Re: Petition No. 1230  
Stony Hill Substation Project - Brookfield  
Conditions #2, #3 and #4

**Condition #2:** Eversource is submitting the attached final Site Plan ("Plan") for the Council's review and approval, which details road and substation clearing limits, contours, grading, drainage control and E&S controls".

ATTACHMENT  
Petition No. 1230  
Stony Hill Substation Site Plan

## STONY HILL SUBSTATION SYNCHRONOUS CONDENSER

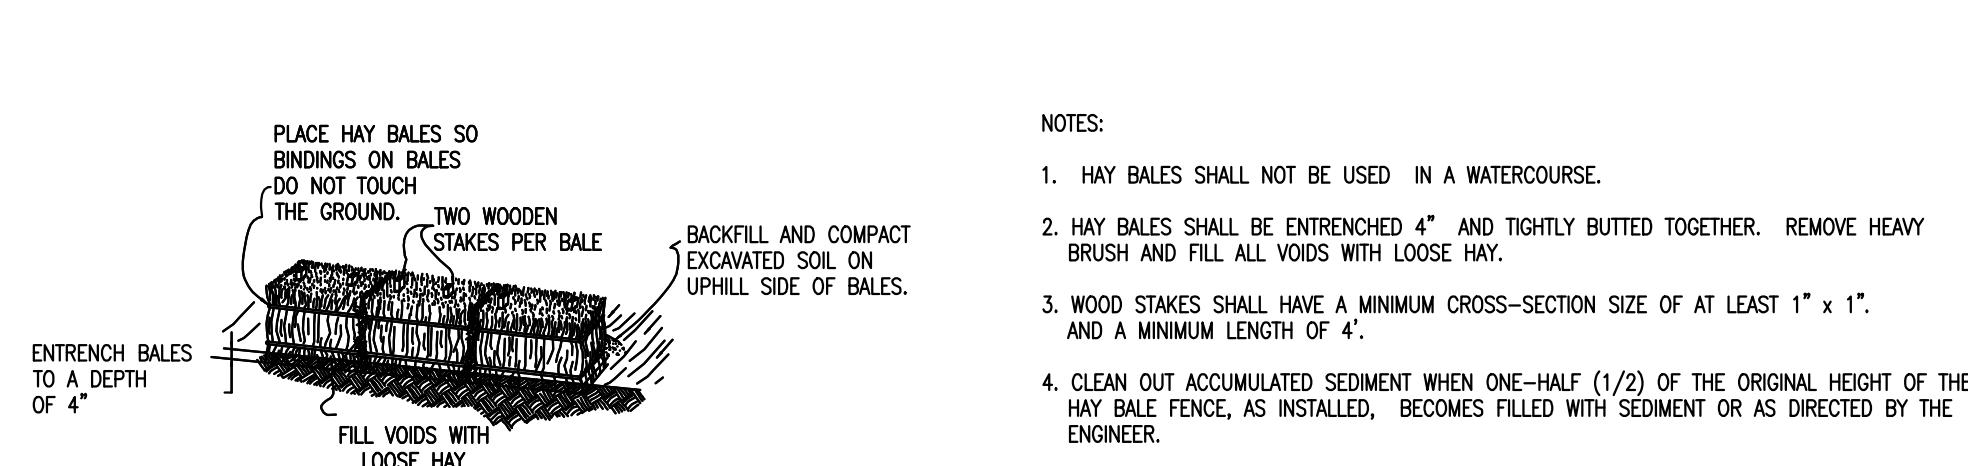
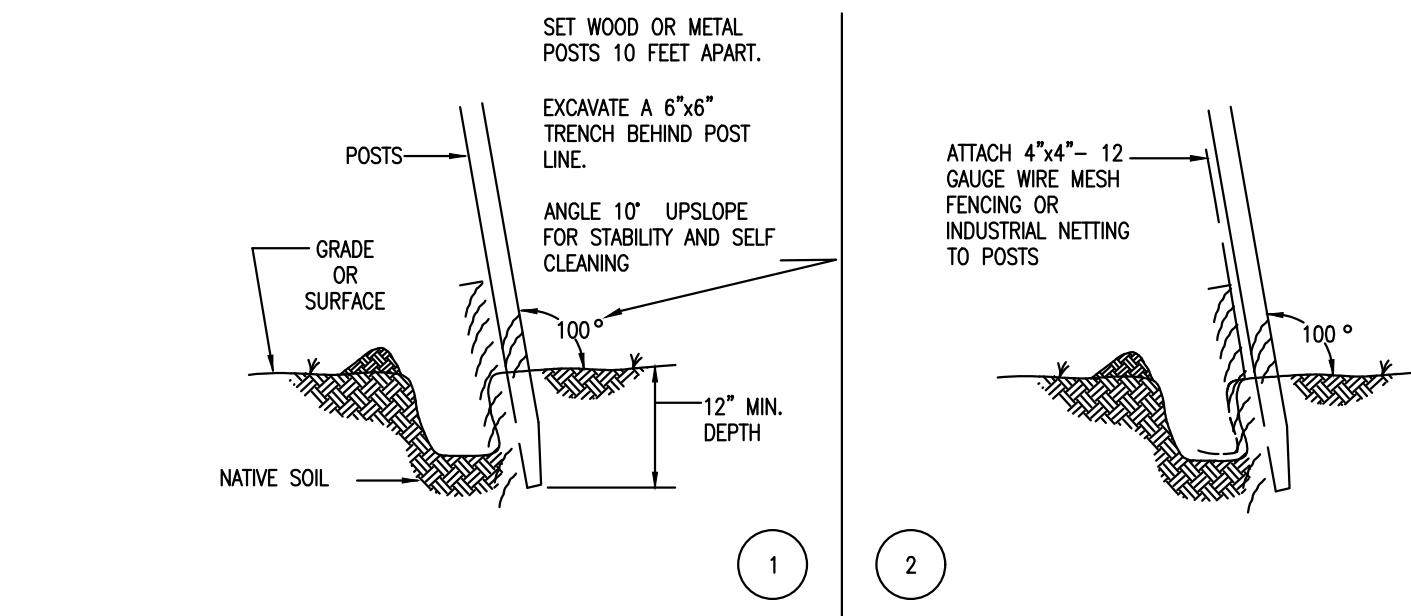
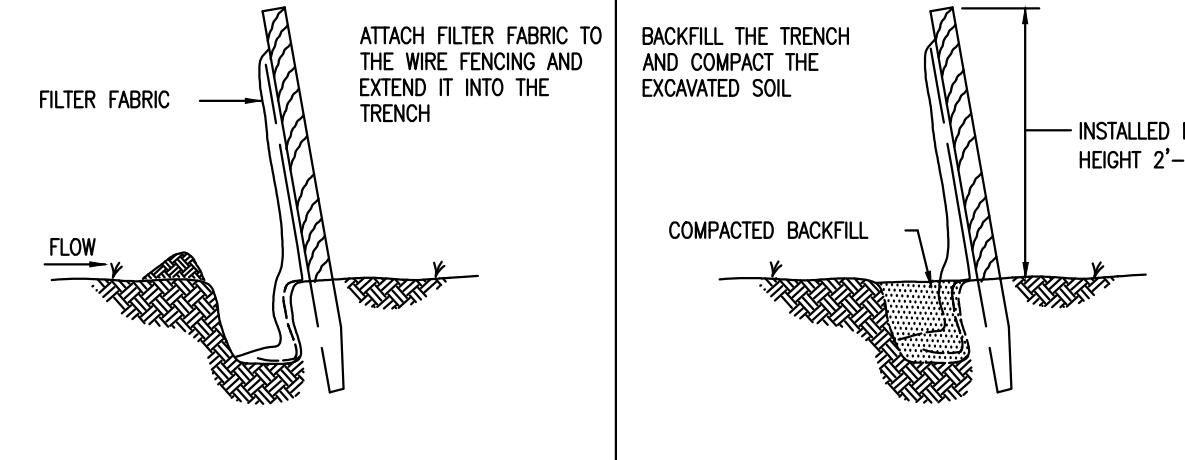
In the letter dated November 1, 2016, Eversource notified the Council that the existing access will be used with modifications and minimal clearing. Since that time, Eversource has also reviewed and re-evaluated the civil requirements to accommodate the delivery, construction, installation of the Project components. Based on this supplemental review, the Plan includes the following modifications regarding the existing access road:

- Improvements to the existing access road on Eversource Property such that there will be created a temporary re-alignment of the existing access to support construction and a final permanent re-alignment prior to the completion of the Project.
- Replacement of the existing Substation 20 foot access gate from Stony Hill Road with a new 20 foot gate. The new gate would be relocated seven feet to the southeast from the existing location.
- Installation of a temporary retaining wall to provide safe vehicular travel on the temporary road during construction. The retaining wall would be removed after the installation of the permanent road.

- Avoid permanent wetland impacts.
- Avoid significant clearing. Additional, minimal vegetation removal would be required on the east and west side of the Substation driveway for construction materials.
- Avoid substantial re-grading and permanent retaining walls.
- Avoid interference with existing transmission infrastructure on the north side of the Substation that will be modified under Docket 468: Southwest Connecticut Reliability Project.

- An angled entrance to the eastern side of the expansion area at lower grade resulting in a curved northeast corner and reduction in height and fill for the northeast corner slope.
- Slight alteration of originally proposed fence line on the southeast side of the approved expansion area.

The proposed modifications would be located entirely on Eversource Property and would avoid any impacts to the wetland areas around the Substation. Construction of the Project would conform to best management practices for erosion and sedimentation controls and the Company's other BMPs, as stated in Petition 1230 and as depicted on the attached Plan.

## TEMPORARY ACCESS DRIVE PROFILE

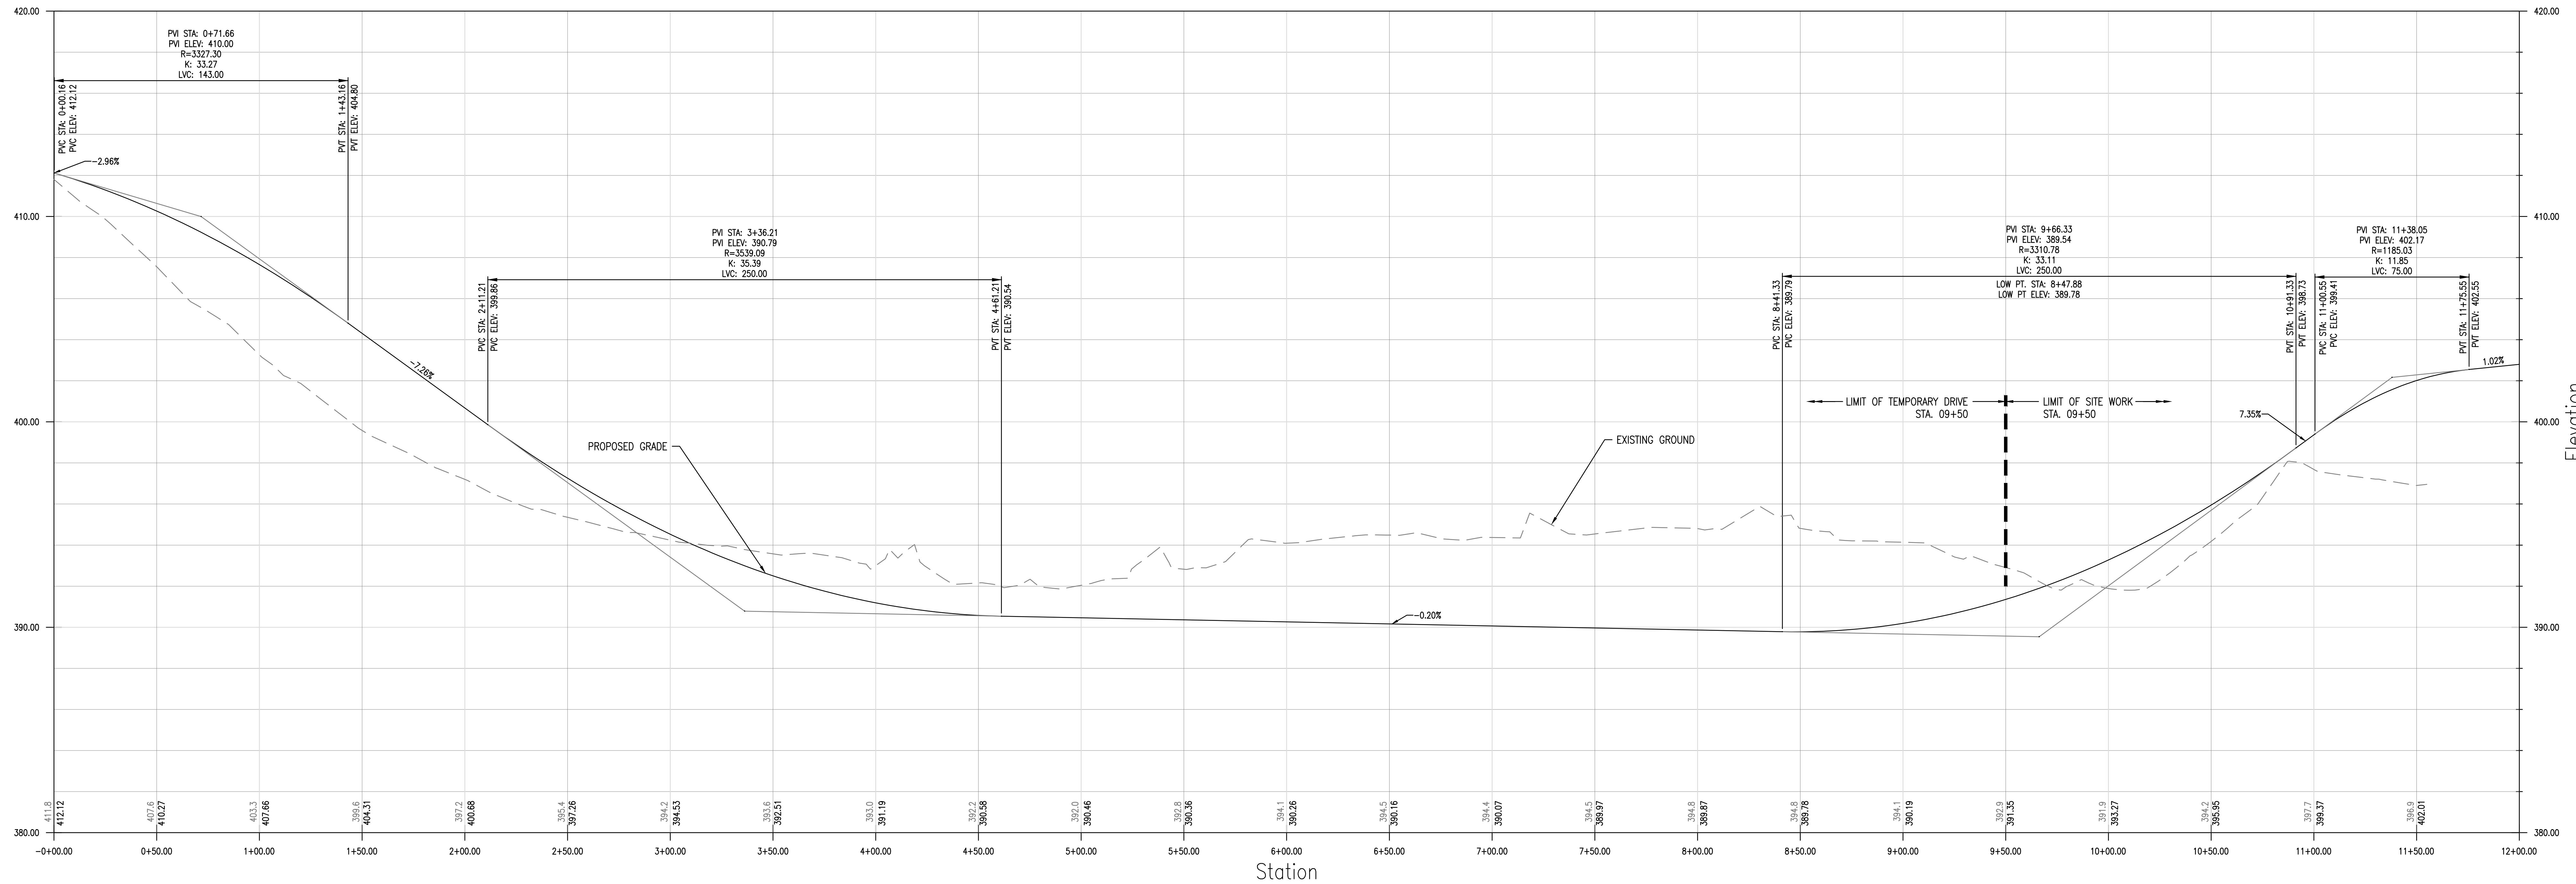
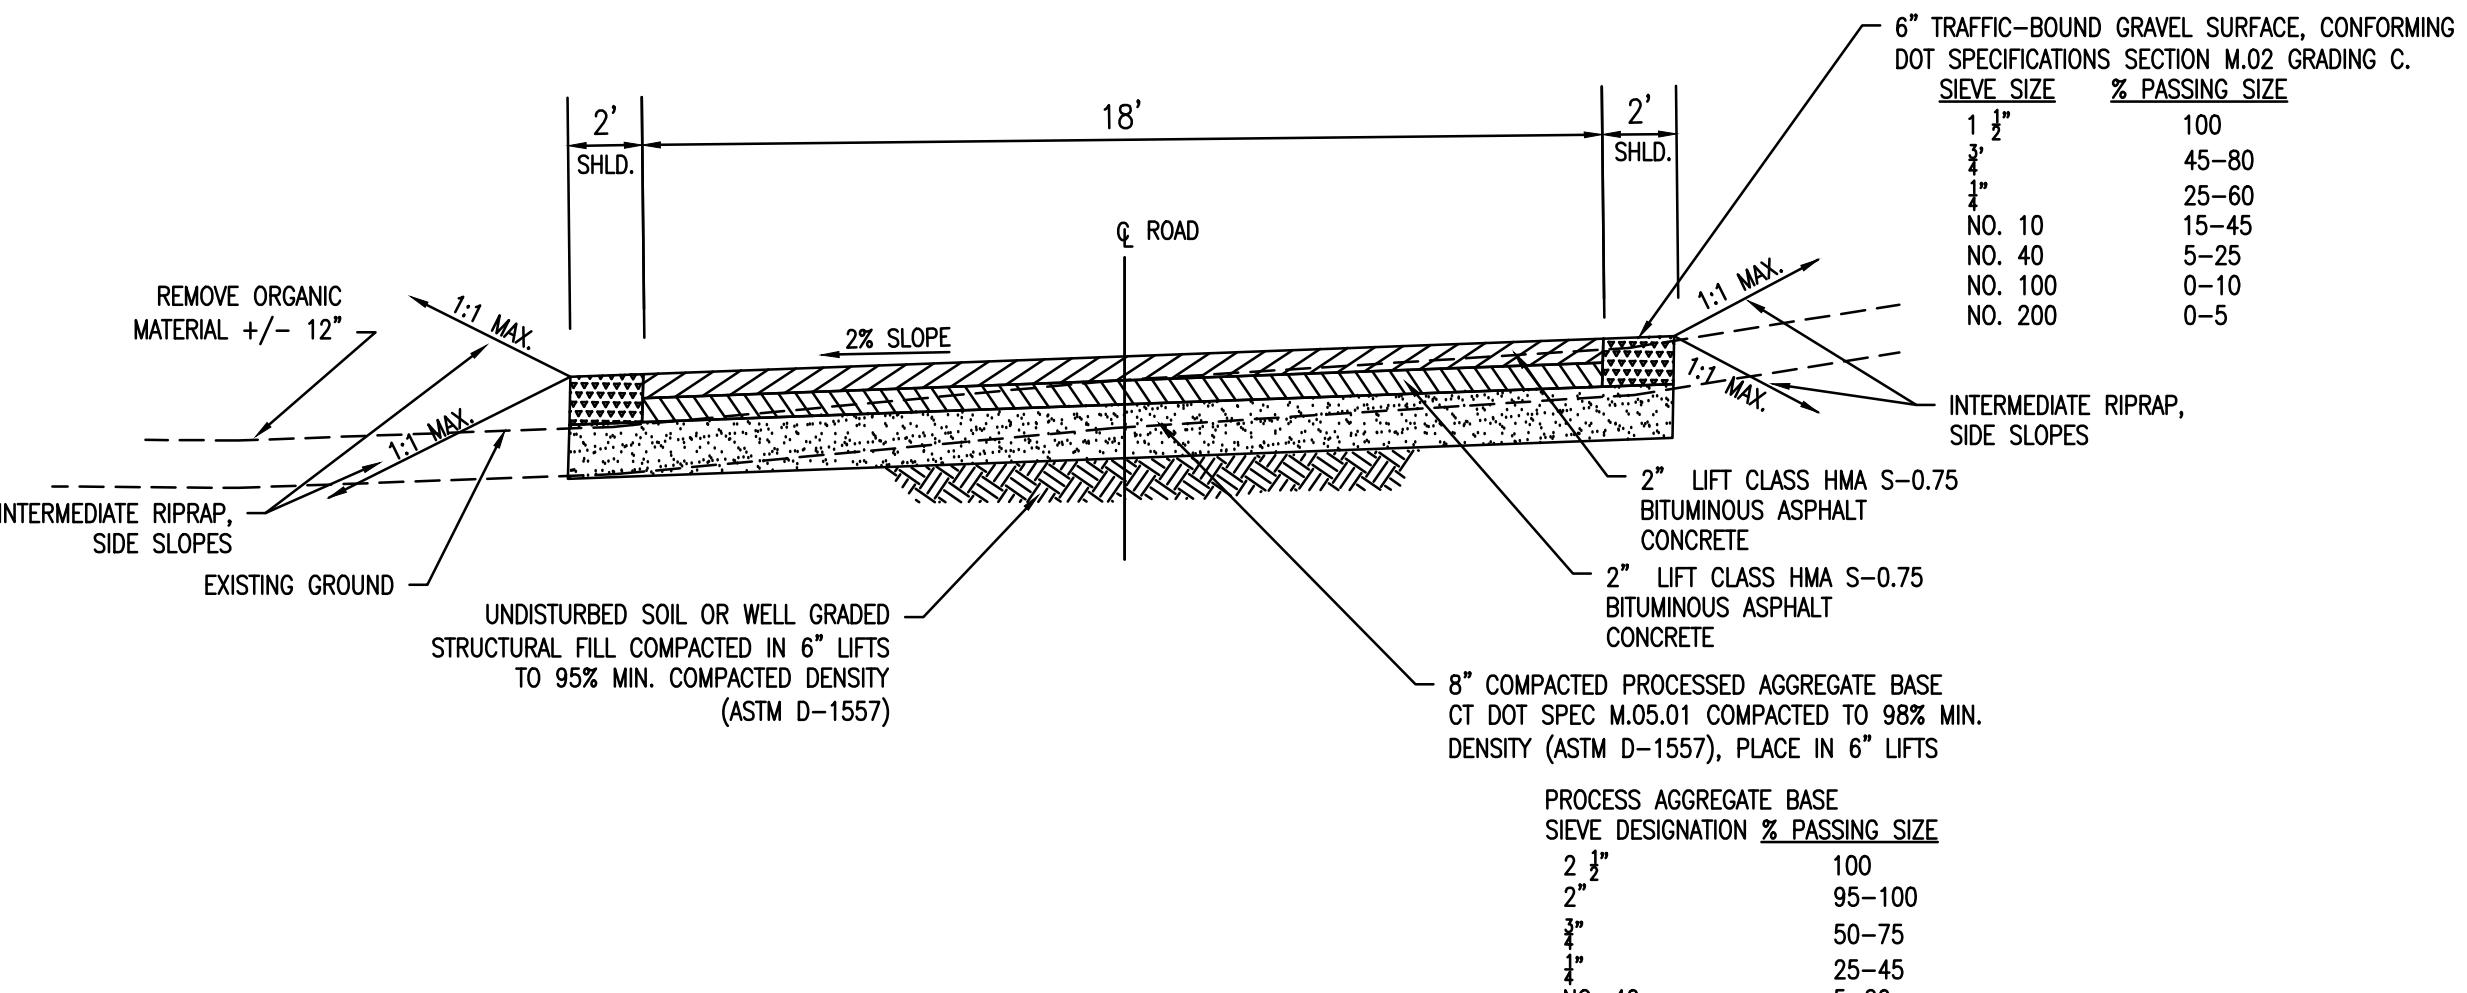
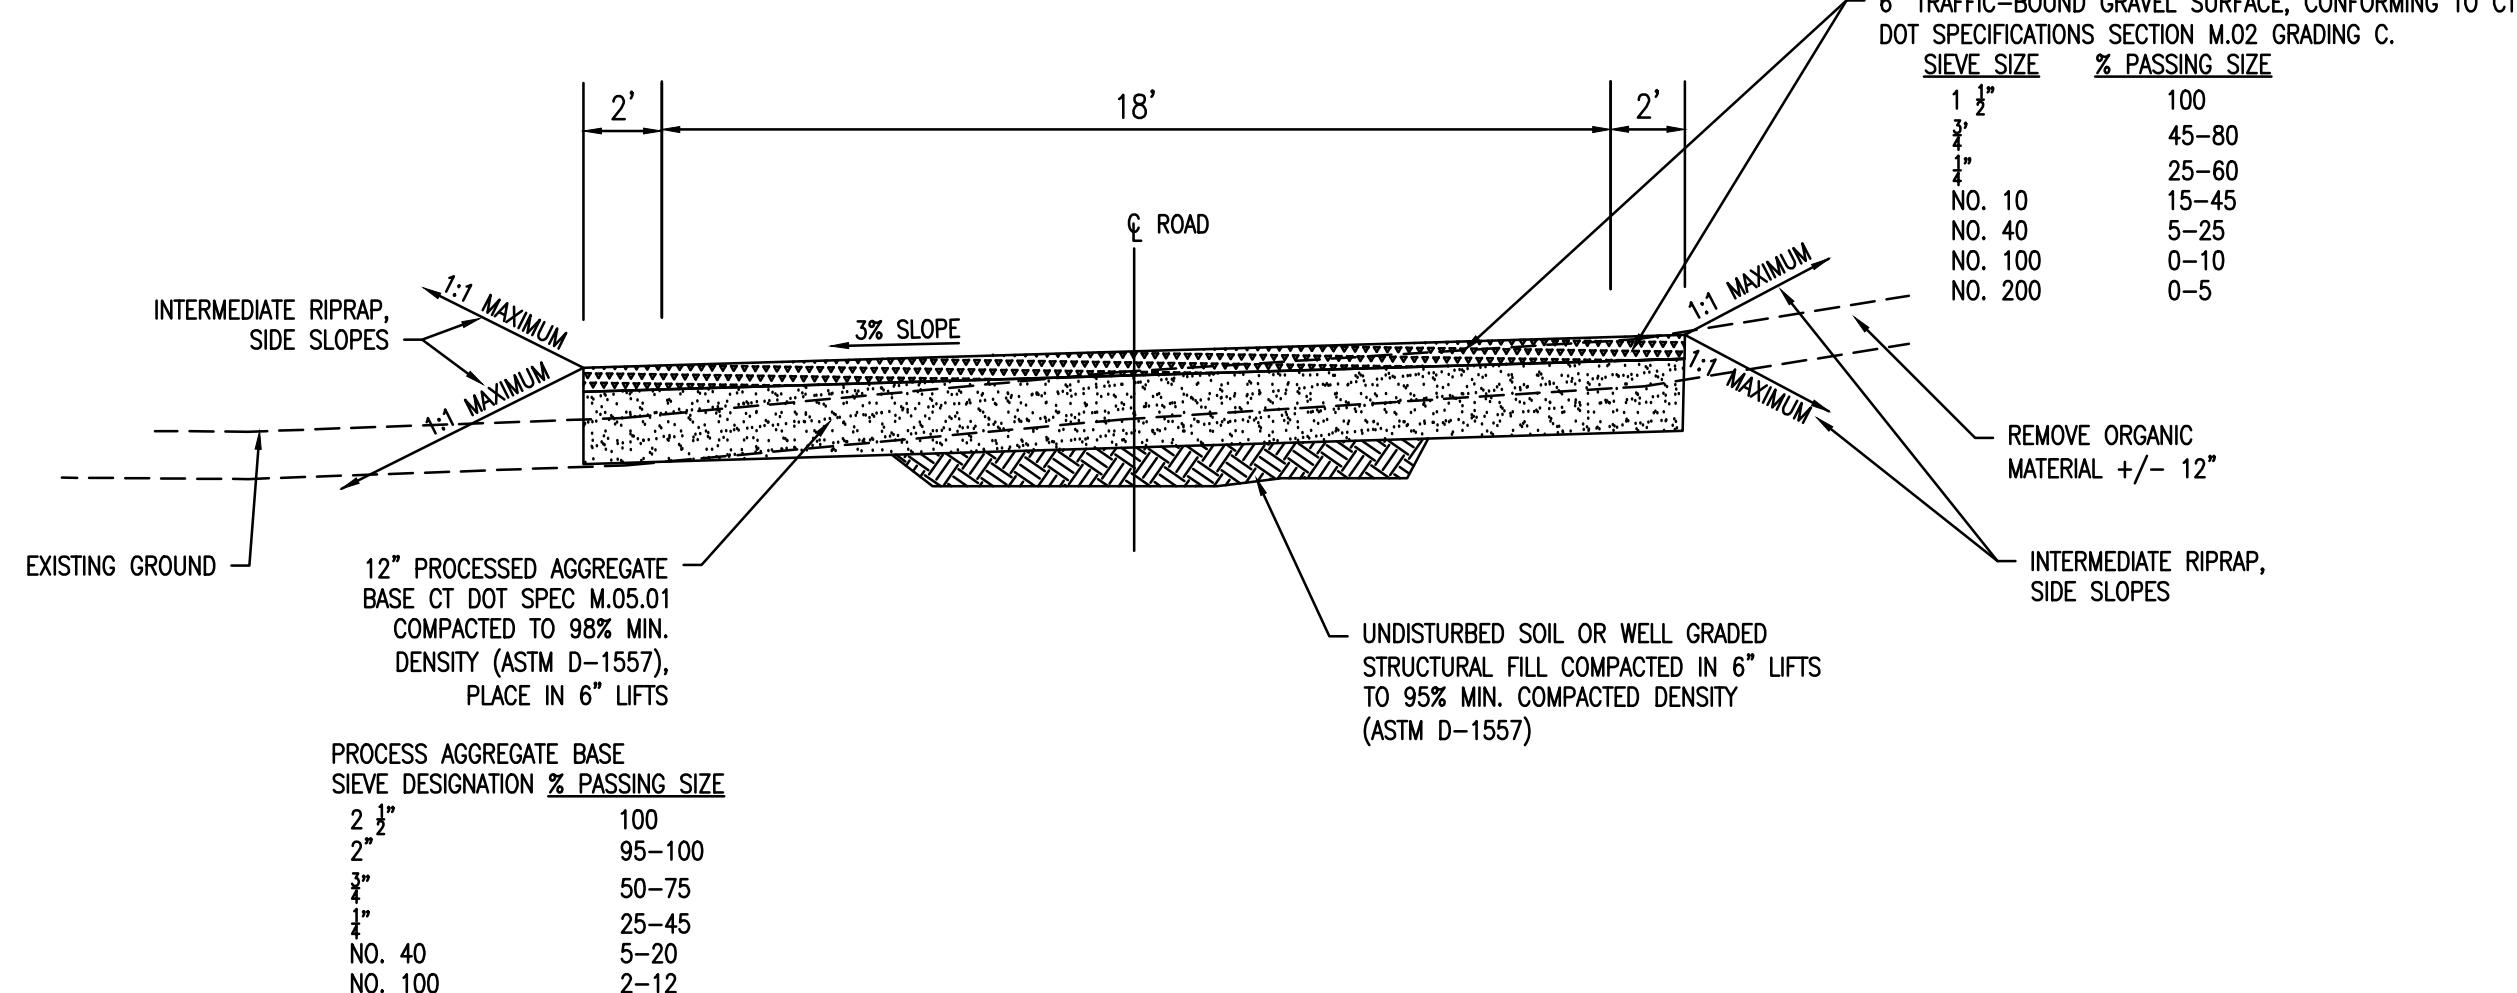
Installation of the temporary access road is proposed to commence in June 2017. The removal of the temporary road and the installation of the permanent access road are proposed to be completed by May 2018.
